Staff Report Memorandum September 7, 2023

To: Planning Commission
From: Community Development Department
Subject: Sandy Station Block 20 Subdivision
(Preliminary Subdivision Review)
240 East 8960 South
(Community #4, Historic Sandy)

SUB09282022-006410
R-1-7.5(HS)
.23 Acres
2 Lots

SANDY STATION BLOCK 20 SUBDIVISION

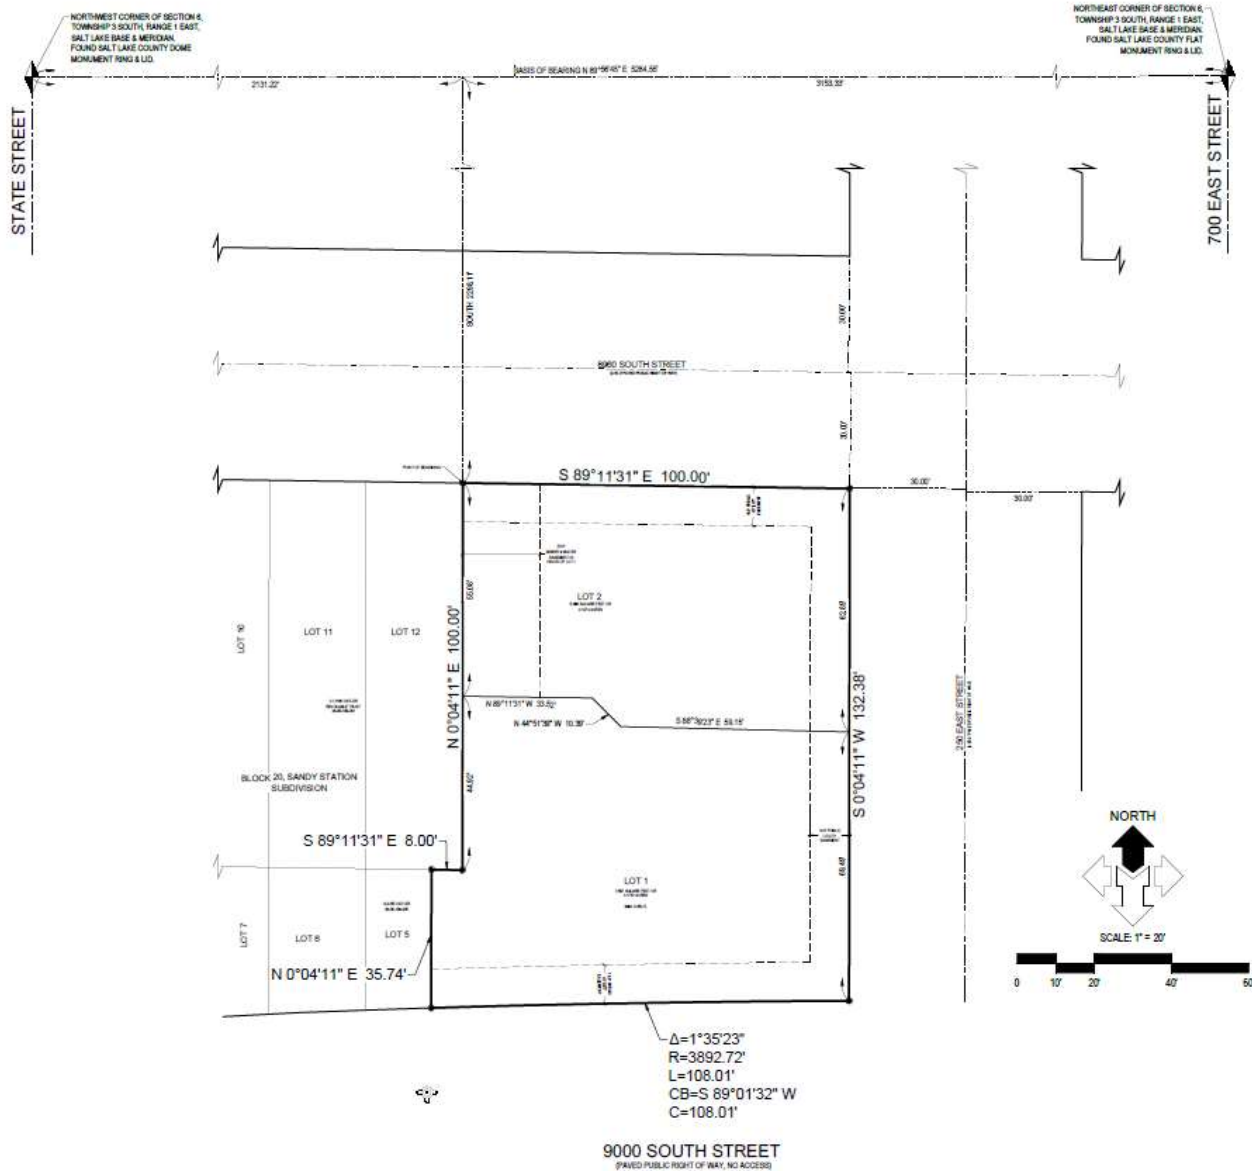
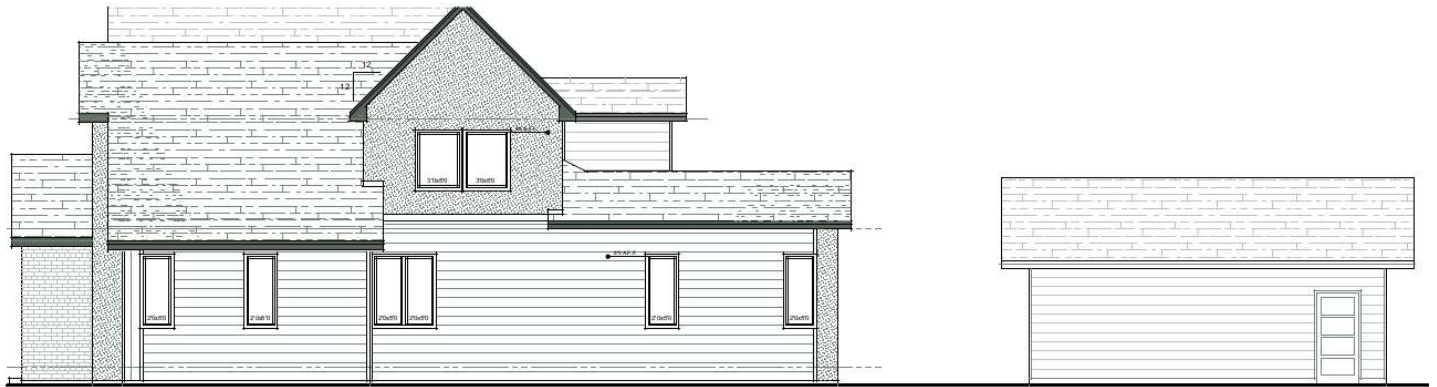
Staff has reviewed the proposal for compliance with the underlying zoning as well as the HSD Overlay requirements and it does meet those criteria. However, it proposes to create lots that are irregular shape and not substantially at right angles.

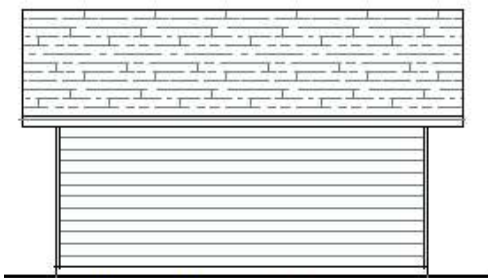
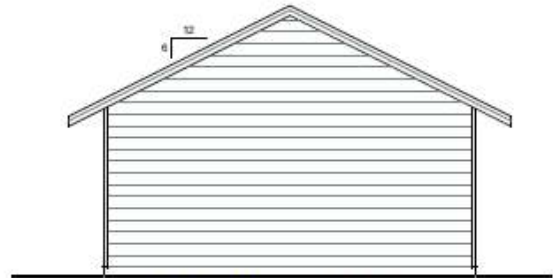
An additional requirement of the HSD Overlay Zone is that development plans must be presented before the Historic Preservation Committee for review. This review took place on August 23, 2023. While admitting that the proposal meets the specific requirements of the HSD Overlay Zone, the Committee did not recommend approval of the proposal based upon the following concerns:

- The excessive mass of the front elevation of the home is out of character when compared with adjoining homes within the district.
- There is no consistency in materials or textures on the front elevation resulting in a muddled design.

The Committee was also concerned as the interior plans appear to be creating the potential for a basement apartment. This concern is beyond the purview of the Committee.

The Planning Commission must review and approve of the proposed building elevations which are found in Exhibit B.

4. That the building elevations for the new structures proposed by the applicant be approved as shown in the application materials.
5. That the existing home have a new detached garage built within six months of the recordation of the subdivision or prior to the sale of the lot to another owner to ensure that this lot remains in a legal conforming condition.
